Work Order ID 79114

Item Name: Replacement Skidtube

DESIGN	RF	DART AEROSPACE LTD HAWKESBURY, ONTARIO, CANADA	
DRAWN	RF		
CHECKED	RF	DRAWING NO.	REV. E
MFG. APPR.	RF	D2580	SHEET 3 OF 8
APPROVED	RF	TITLE	SCALE
DE APPR.	RF	205 SKIDTUBE ASSEMBLY	NTS
DATE	11.06.21	COPYRIGHT © 1996 BY DART AEROSPACE LTD THIS DOCUMENT IS PRIVATE AND CONFIDENTIAL AND IS SUPPLIED ON THE EXPRESS CONDITION THAT IT IS NOT TO BE USED FOR ANY PURPOSE OR COPIED OR COMMUNICATED TO ANY OTHER PERSON WITHOUT WRITTEN PERMISSION FROM DART AEROSPACE LTD.

DRAWING NO. D2580	TITLE 205 SKIDTUBE ASSEMBLY	REV. E	DART AEROSPACE LTD ENGINEERING ORDER		D.E.O. NO. D2580-E-1	SHEET NO. SHEET 1 OF 1	SCALE NTS
DRAWN <i>UP</i>	CHECKED <i>ASS</i>	MFG. APPR. <i>ER</i>	APPROVED <i>[Signature]</i>		DE APPR. <i>[Signature]</i>		
DATE 11.12.13	DATE 11.12.13	DATE 11.12.13	DATE 11.12.13		DATE 11.12.13

D5-2
SECTION B-B
SCALE 5X

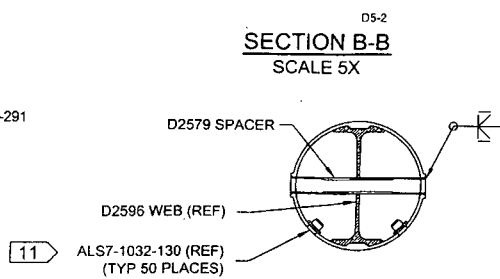
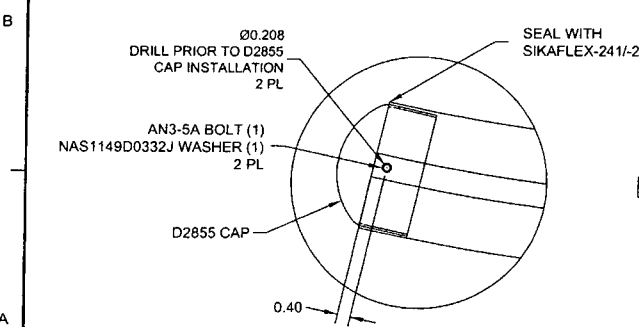
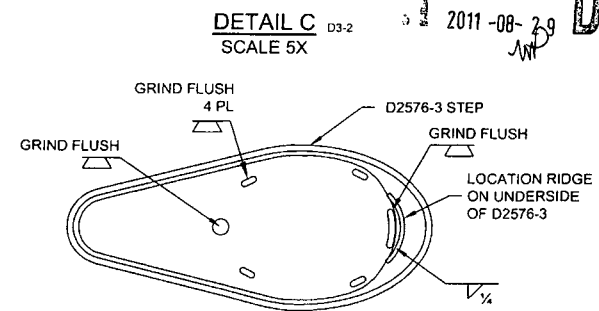
**AFTER DRILLING AND BENDING ASSEMBLY
PERFORM THE FOLLOWING FOR Ø0.508 HOLES ONLY:**

- 1. CHAMFER HOLE 0.050 X 45°**
- 2. INSERT D2579 SPACER (20 PLACES)**
- 3. WELD INTO PLACE AND GRIND FLUSH**
- 4. C'BORE D2579 SPACER TO Ø0.437 X 1.00 DEEP**

1. INSERT D4202-1 SPACER, 20 PL (-041) OR 20 PL (-045) OR 25 PL (-047)
2. SWAGE TO Ø0.437 X 1.00 DEEP PER QSI 002
3. TRIM / GRIND FLUSH PER QSI 002

SECTION B-B, SECTION F-F, & SECTION I-I ARE AMENDED AS FOLLOWS
FOR ALL HOLES THAT WERE ORIGINALLY C'BORED:

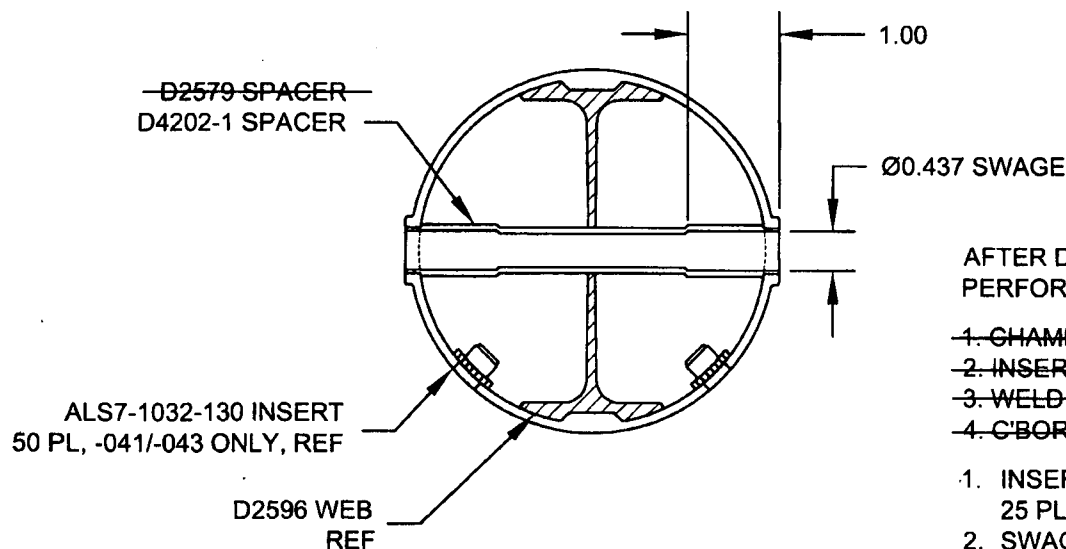
PURPOSE:

CHANGE ALL C'BORED WELDED CROSSBOLT SPACERS TO SWAGED SPACERS

WELD 4X D2579 SPACERS PER DWG
IN LOCATIONS MARKED "NO C'BORE".
REF SHEET 4 OF DWG.

- ~~1. CHAMFER HOLE 0.050 X 45°~~
- ~~2. INSERT D2579 SPACER (20 PLACES)~~
- ~~3. WELD INTO PLACE AND GRIND FLUSH~~
- ~~4. C'BORE D2579 SPACER TO Ø0.437 X 1.00 DEEP~~

SECTION B-B, F-F, I-I
NOT TO SCALE
